January 17, 2022

Our Project No.: AA16-190B

**Re: 35, 40 & 55 Silvercreek Parkway South
Scoped EIS Addendum Report**

TP2

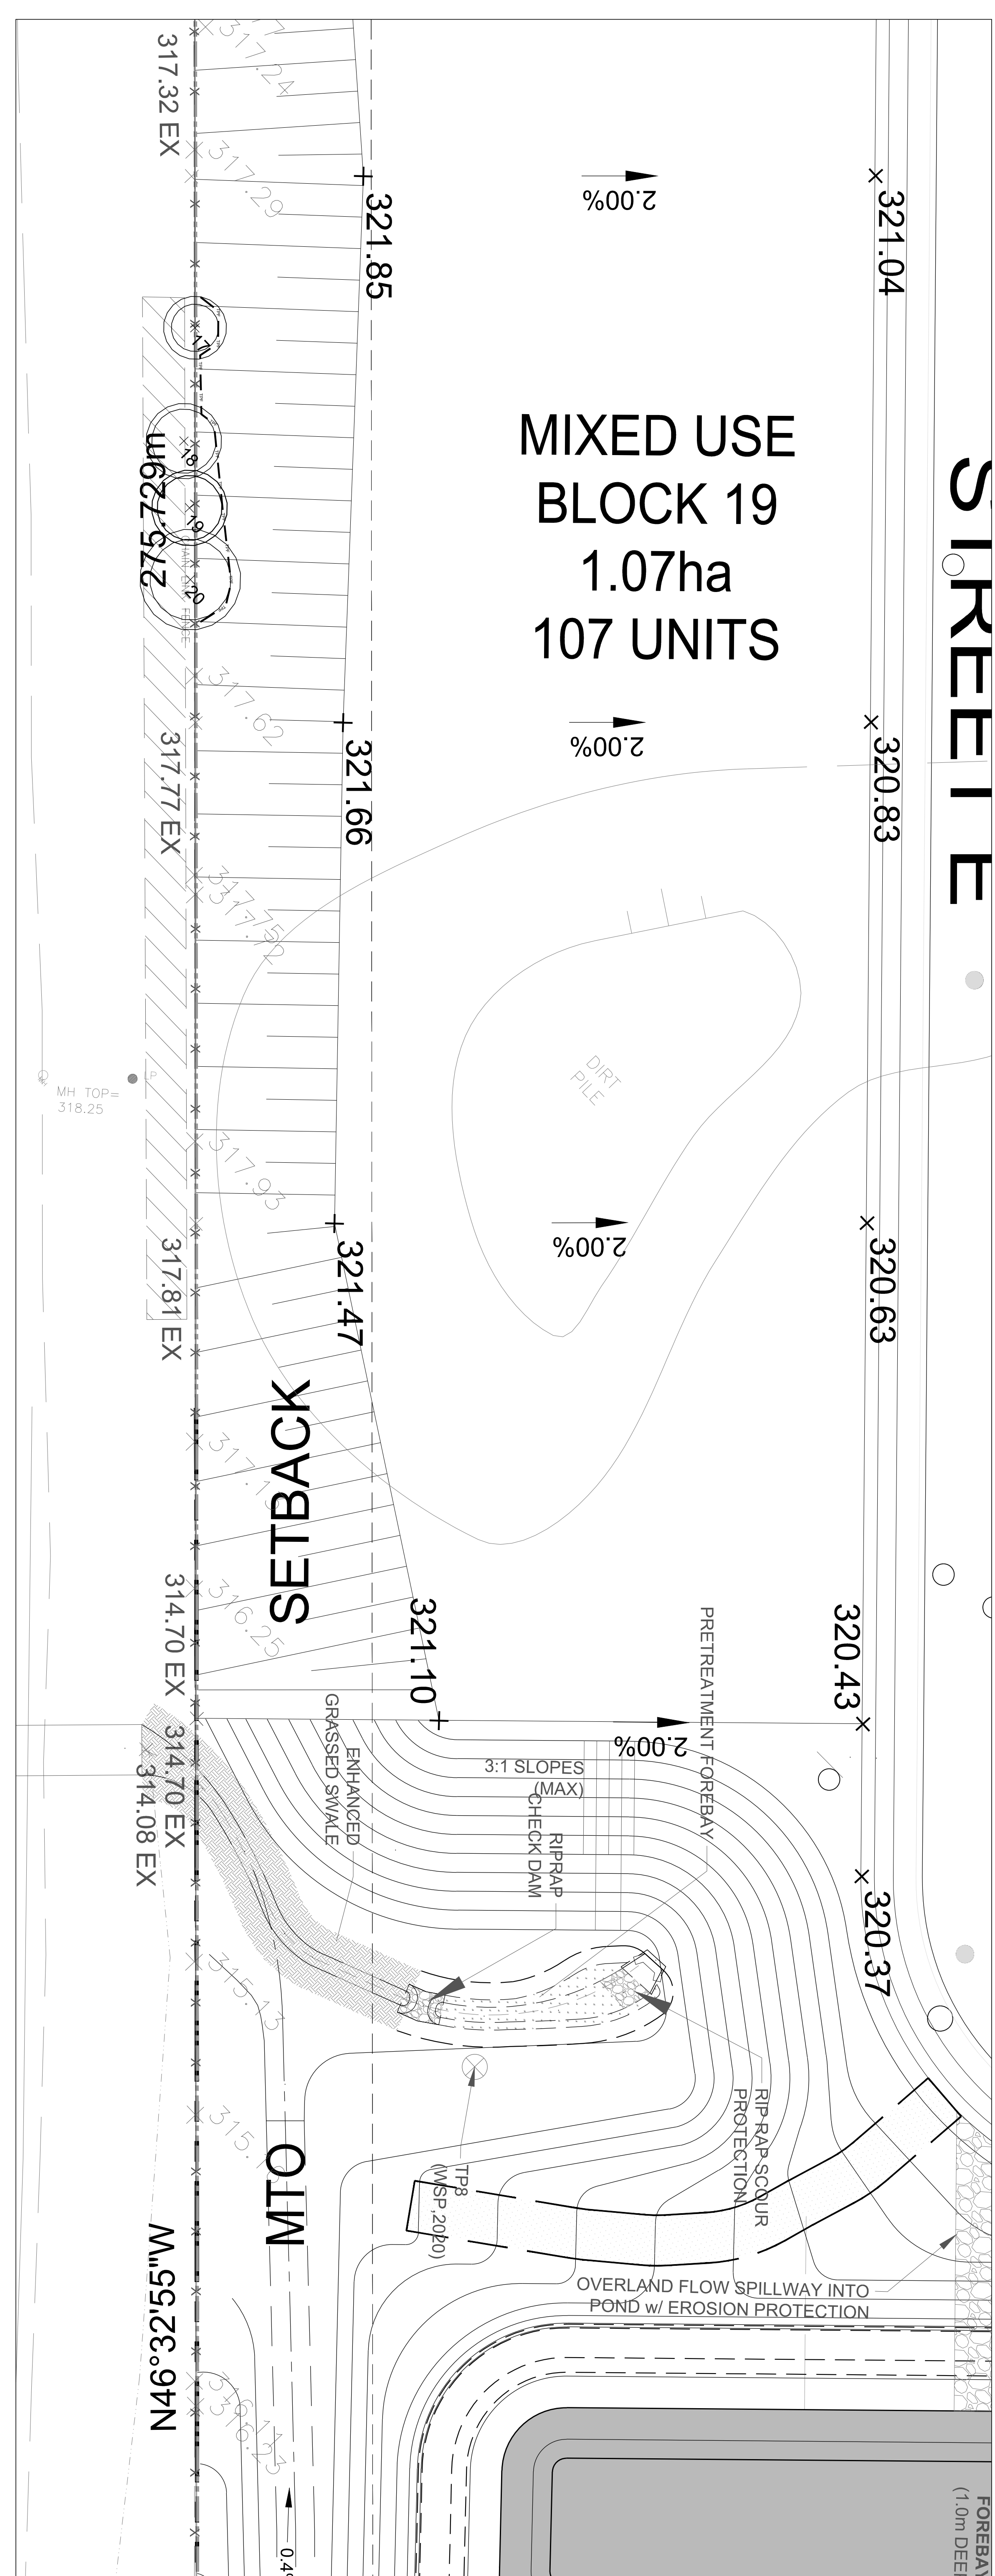
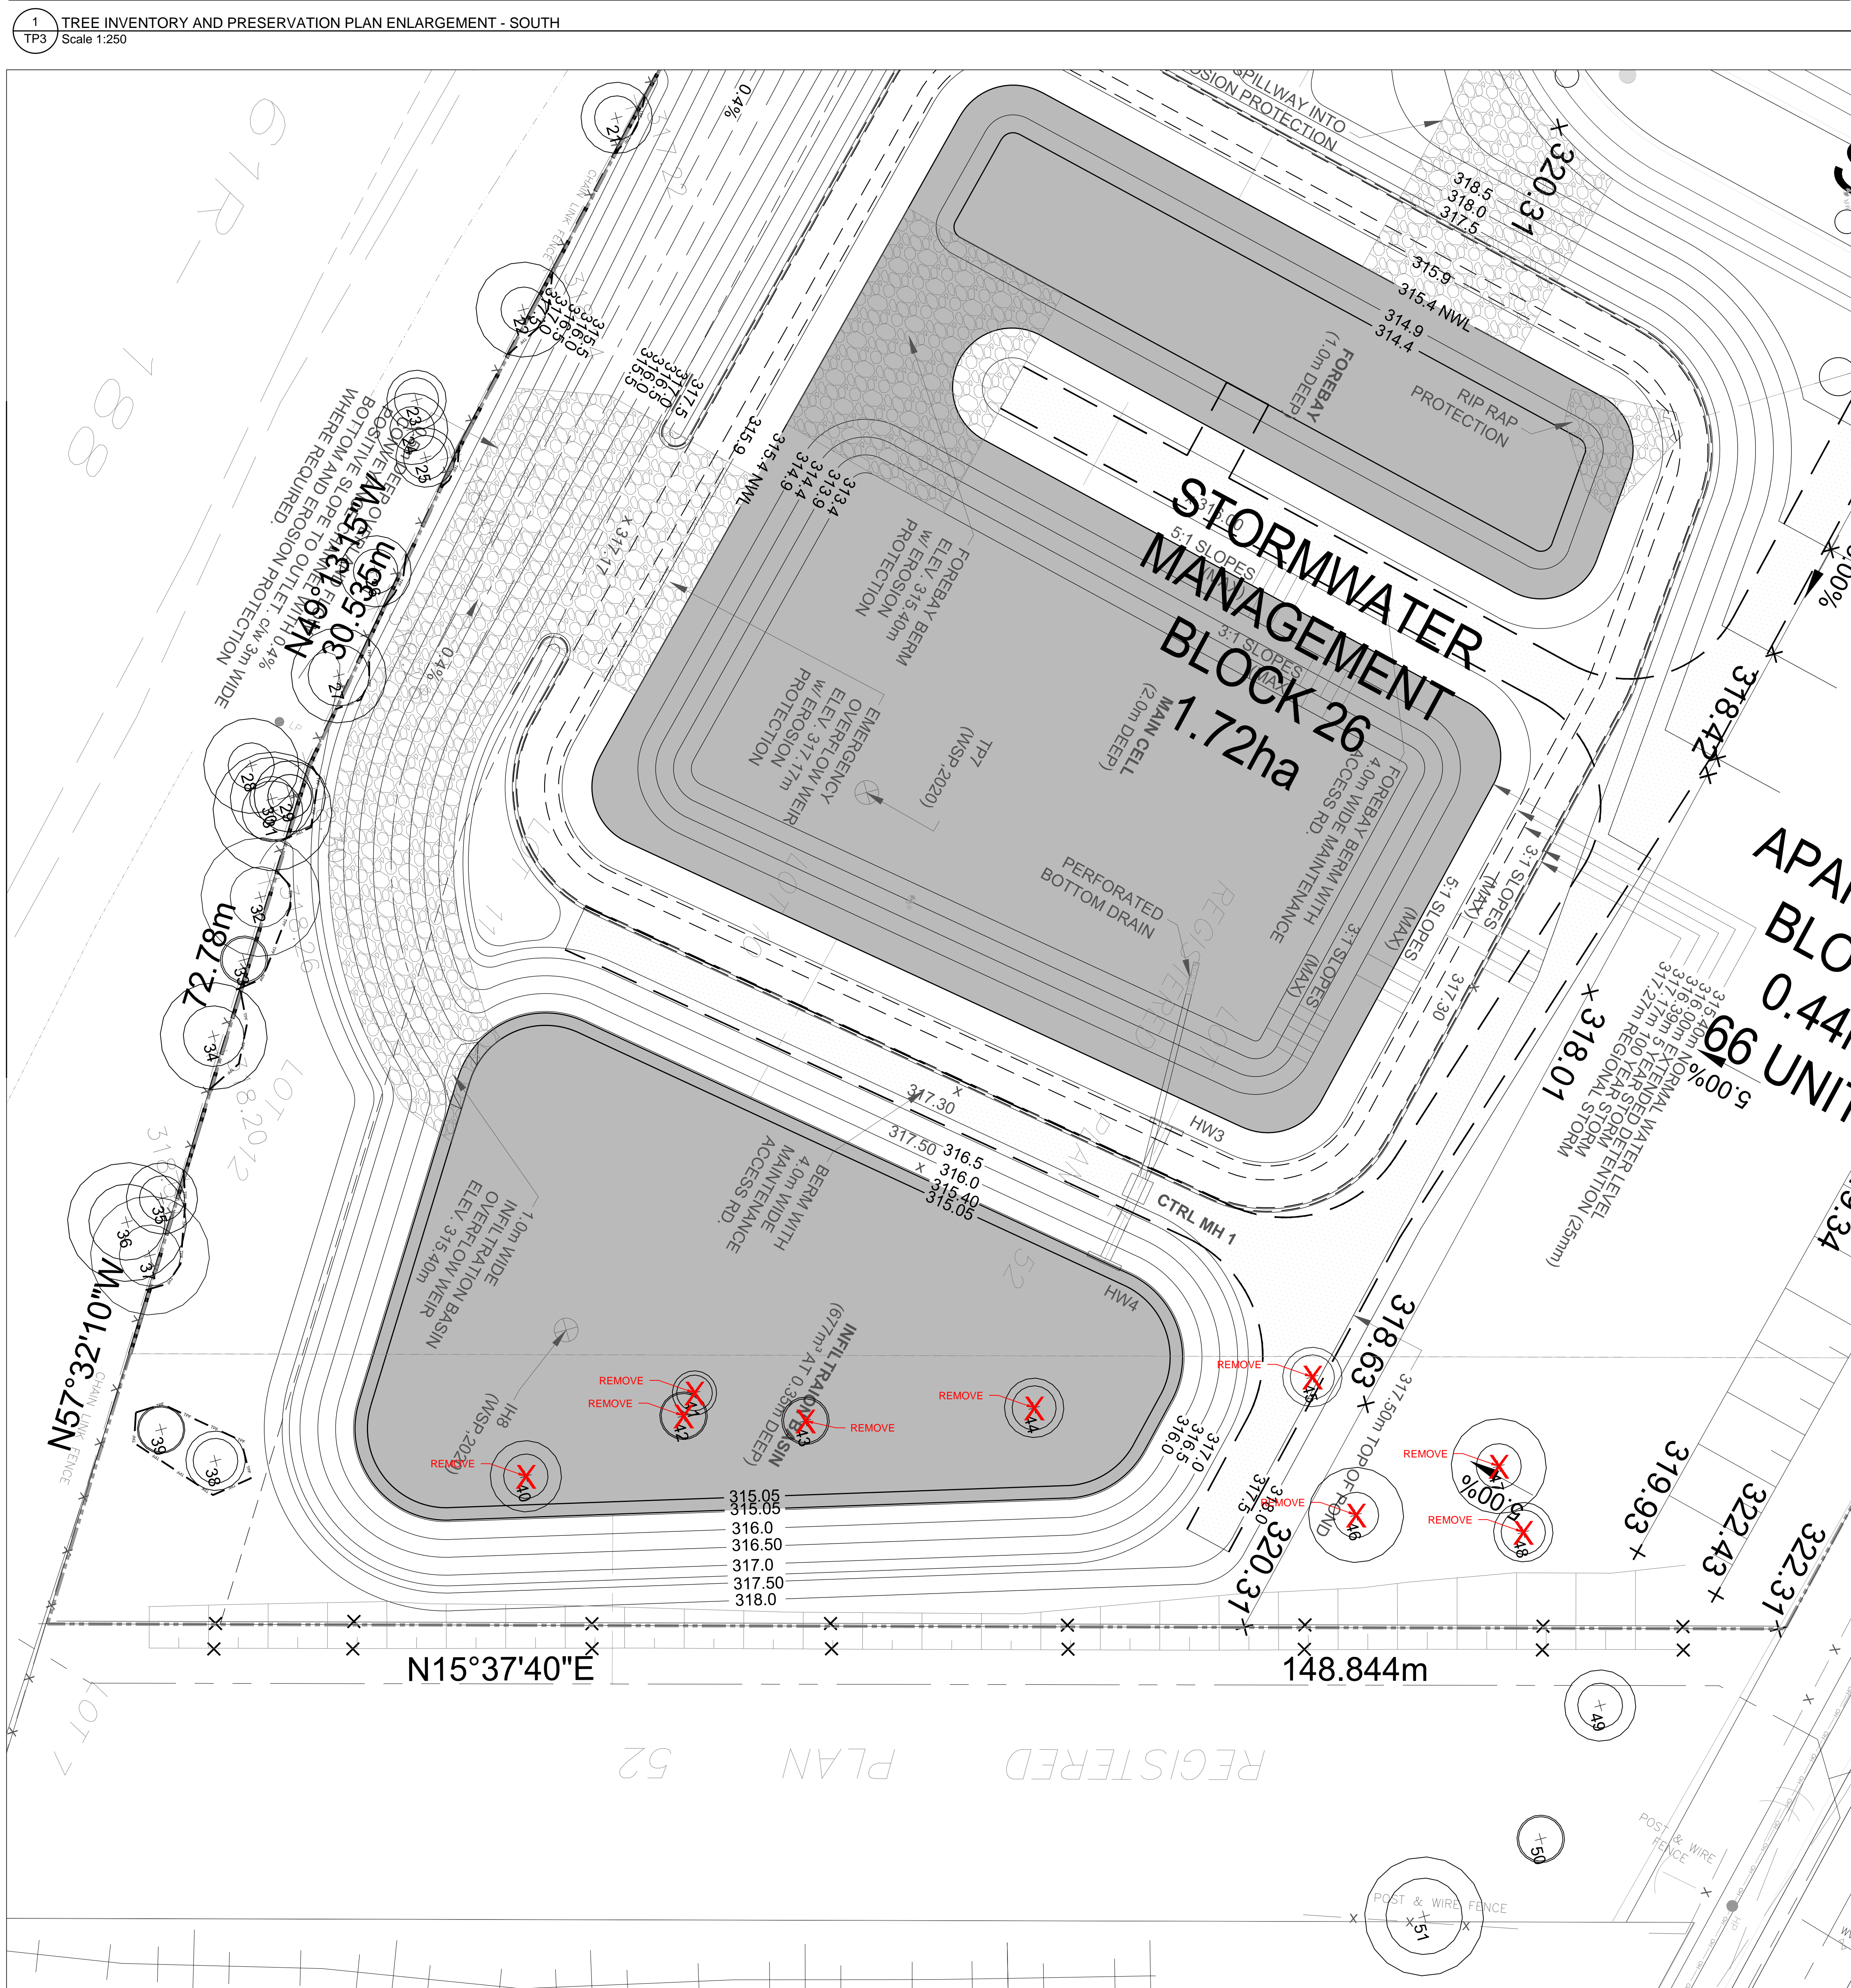
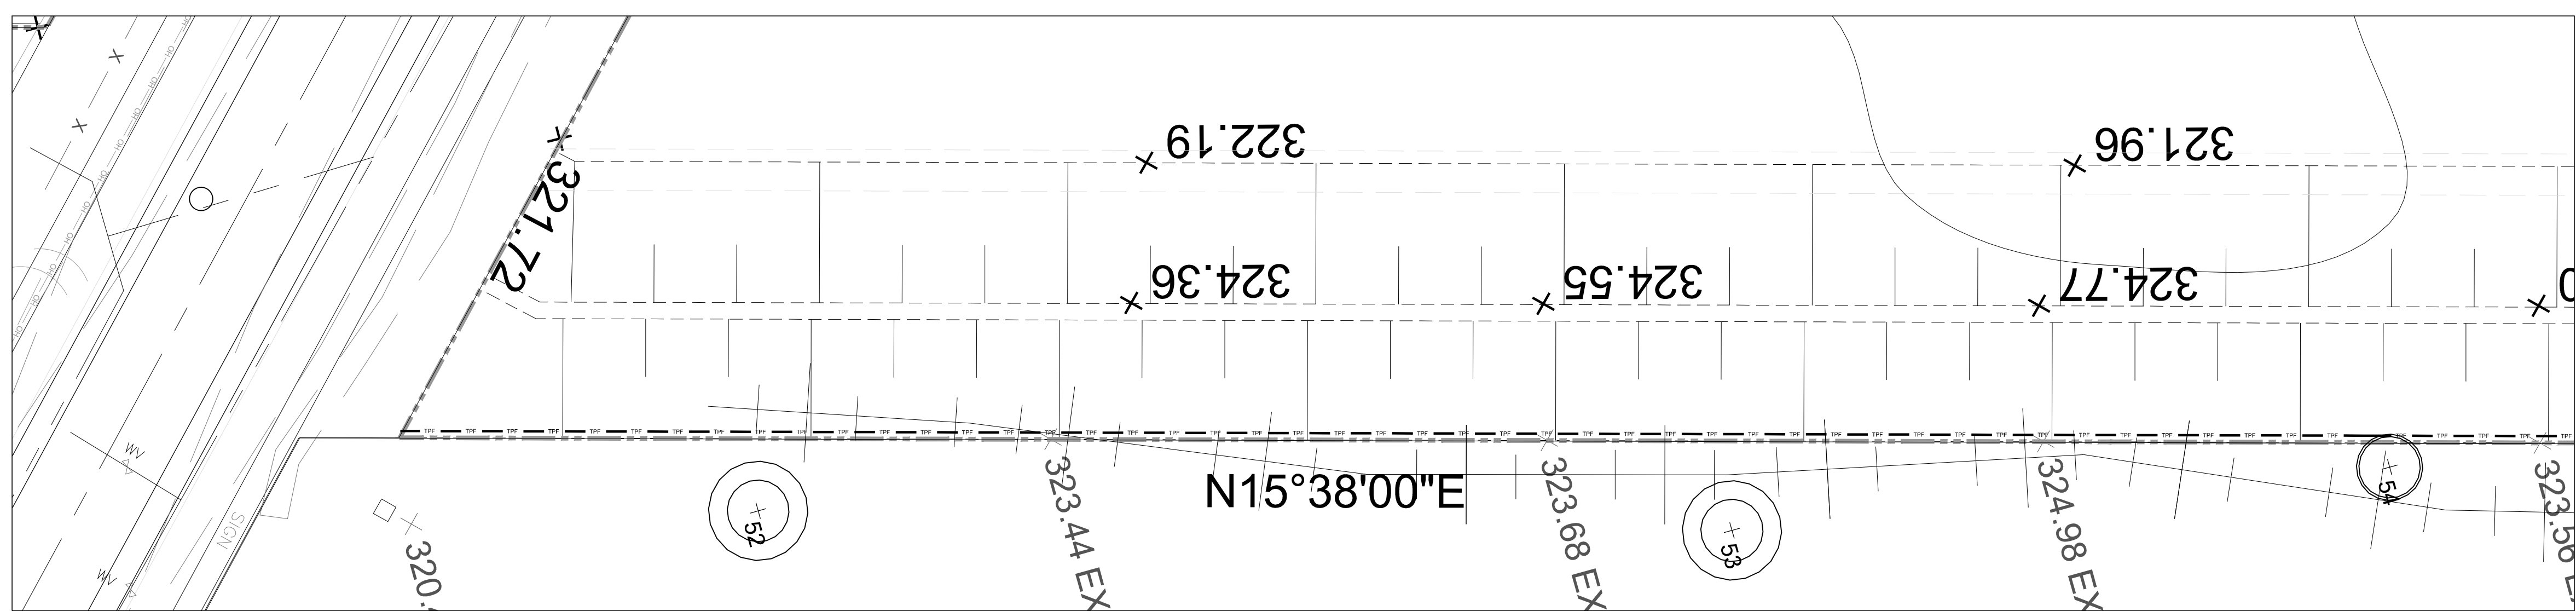
“Per the submitted tree plan and as discussed in Section 4.2 of the EIS Staff acknowledge the new/additional tree removals are required because of the acquisition of the adjacent property, and that the current plan proposes to use this area for a combination of SWM and an apartment block. Please confirm how many trees are being proposed for removal. TP3 shows 11 (which corresponds with the 125mm tree caliper compensation note on TP4), but the tree table includes 19 recommended for removal- including some shared ownership trees. Do these other 7 trees warrant discussion with the City regarding their removal? Please clarify.”

The Tree Preservation Plan (*Appendix 1*) has been updated to clarify the recommendations regarding offsite and share trees in poor or dead condition. Trees that will not be affected by the work are either boundary or offsite should be retained and managed at the owner's discretion. The updated plan will show 11 trees to be removed due to development, 9 of which will require compensation.
